EXPRESS GROUP PTY LTD

UPDATED TRAFFIC REPORT FOR
LEP AMENDMENT TO INCLUDE
TRUCK FACILITIES AT
194 CAMPBELLTOWN ROAD,
DENHAM COURT

AUGUST 2020

REF: 10909/3

**Weekday morning peak hour
traffic flows plus approved
development traffic**
Figure 4

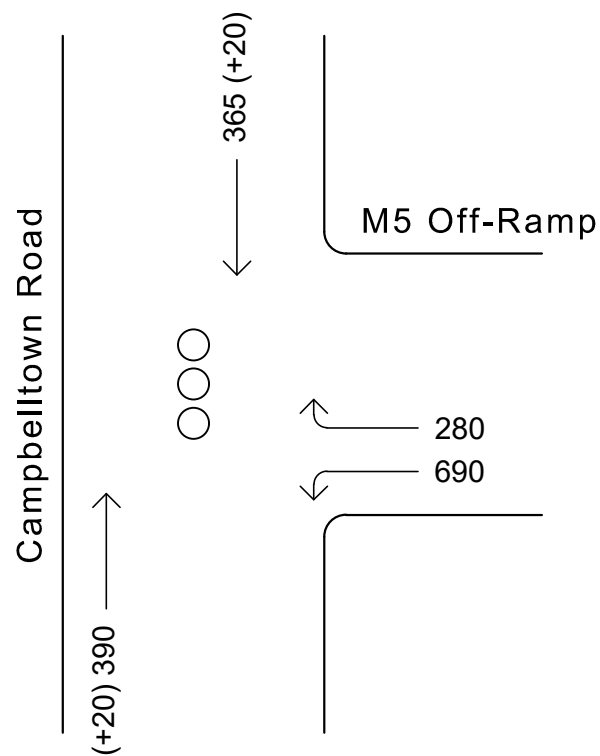
- *Impact of design vehicle entering the site on the operational performance on the intersection of Campbelltown Road/Hume Highway off-load ramp.*

- 2.25 The intersection of Campbelltown Road with the M5 ramp has been re-analysed with SIDRA for the additional approved development traffic flows shown in Figures 4 and 5. The analysis found that the intersection would continue to operate with average delays of less than 25 seconds per vehicle during weekday morning and afternoon peak periods. This represents level of service B, a good level of service.

2.32 The operational performance of the intersection of Campbelltown Road with the M5 off-ramp is discussed in paragraphs 2.16, 2.25 and 2.27.
